# Stage 06: Final Grid Code Modification Report

# GC0100 EU Connection Codes GB Implementation – Mod 1

This modification will set out within the Grid Code the following compliance obligations in the EU Connection Codes:

The purpose of this document is to assist the Authority in making its determination on whether to implement GC0100.

Figure 3.15(a) – GB Proposed Voltage Against Time Curve of a Type B Synchronous Power Generating Module showing the conflict with Stage 2 G59 Undervoltage Protection

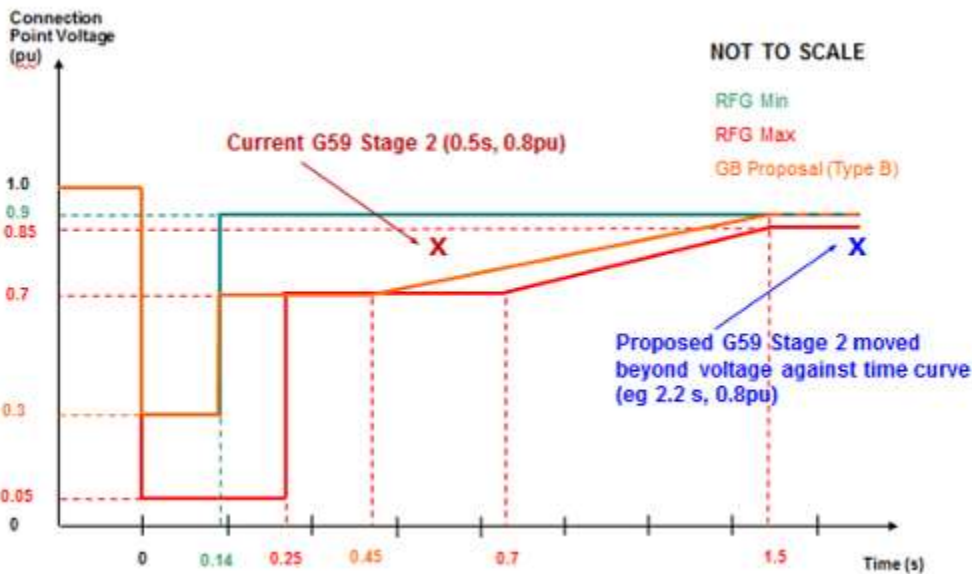
The proposed voltage against time curves for Type B – D Power Generating Modules are detailed above. For those Power Generating Modules which are connected to the Distribution Network, stakeholders noted that there would be a conflict with the G59 under voltage Stage 2 protection which is currently set at 0.8pu for 500ms. Whilst this was marginal in the case of the voltage against time curve for Synchronous Power Generating Modules it was more severe in the case of Power Park Modules where even the minimum RfG voltage against time criteria would have been incompatible with the current G59 Stage 2 under-voltage protection settings.

These issues are shown in Figures 3.15(a) and 3.15(b).

It was not believed that changing the G59 Stage 2 Undervoltage protection would cause a significant problem however it was included as a consultation question. The Grid Code/Distribution Code workgroups GC0035 and GC0079 continue to investigate the issues associated with changing RoCoF protection settings for distribution connected generators and have undertaken a risk assessment of Distribution system protection requirements. The analysis for this has been performed by the University of Strathclyde.

The Workgroup discussed this and The Proposer decided that the best policy for their original solution would be to move the G59 Stage 2 undervoltage protection to 0.8pu at 2.5s. This requirement would apply to all new connecting plant and would be equally applicable to Synchronous Power Generating Modules and Power Park Modules.

Figure 4.5 – Proposed Voltage against time curve for Title II HVDC Converters

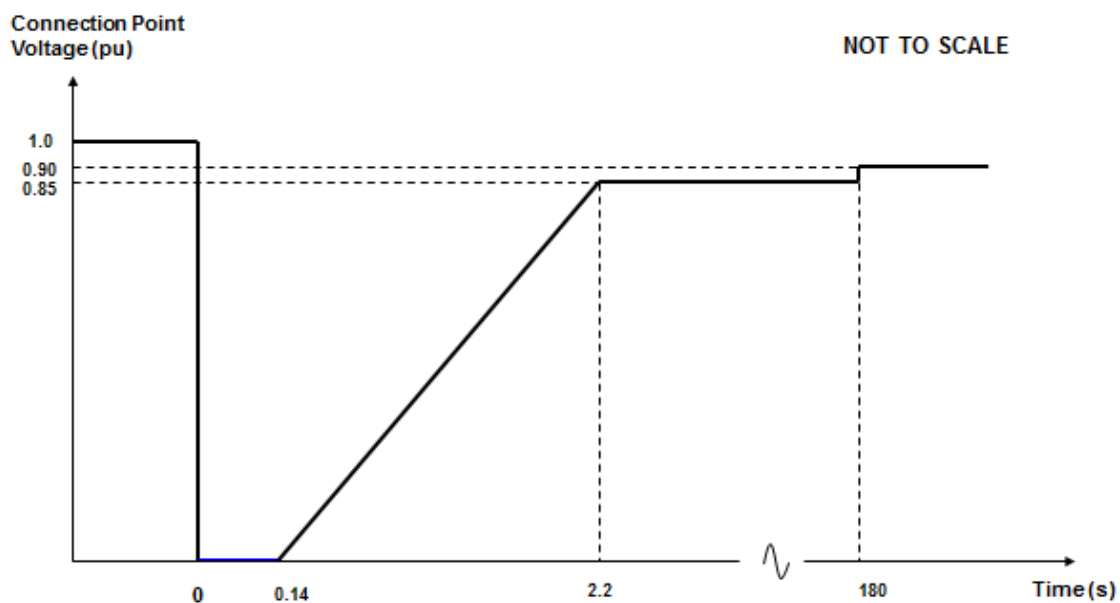
<i>Athanasios Krontiris &amp; Grant McKay, ABB HVDC</i>	The fault ride through curve for HVDC converters in Figure 7.3 is in accordance with the EU network code. However, the fault ride through is not related to fault current injection. Setting Ublock equal to zero practically disqualifies line-commutated converters. During drafting of the EU network code for HVDC, great care was taken to avoid such general disqualifications and we suggest that this may be reconsidered. We would like to further highlight that the instance of fault clearance needs a clear definition. The requirements for FRT and subsequent active power recovery up to 90% within 500 ms from fault clearance must be related to the instance the voltage returns in the 0.9-1.1 pu band. Otherwise significant overrating of the converter is necessary. Note that the term "fault clearance" is also used in Figures 4.4 and in section 4.4, however with another interpretation.

Figure ECC.6.3.15.4 - Voltage against time curve applicable to **Type D Sync**

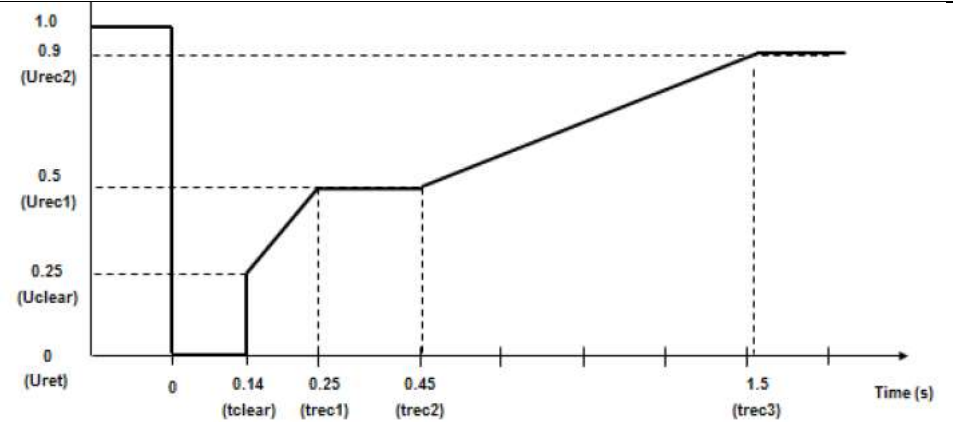
economically achievable by the respective technologies.		
<b>Deep Sea Electronics Plc</b>	The original better facilitates the Grid Code objectives than the WACM. The 10MW band B-C threshold enables separation of reciprocating generation in band B from turbines	Yes	The setting of Uret to the highest permissible level for band B synchronous generators is crucial to the small synchronous generator industry as lower values are impractical and uneconomic to support.
<b>Electricity North West</b>	Yes	Yes	None
<b>Scottish Power Generation</b>	We believe alternative WACM1 is better as per reasoning given in WACM1 proposal	Yes	No
<b>GE Power</b>	Yes, for the national implementation of the Connection Codes	Yes	FRT, EEC.6.3.15.4 and Appendix 4, ECC.A.4A.2

It is our understanding that the bold line in Figure ECC.6.3.15.4 shows the definite voltage profile at a Grid Entry Point for the time range 0-140ms; the profile after 140ms has a different meaning, namely a grid response to a fault which the plant should withstand. This is supported by Figure EA.4.2(a). Would it be more profitable to mark the definite voltage profile and the limiting grid response components in a different way for easier understanding.
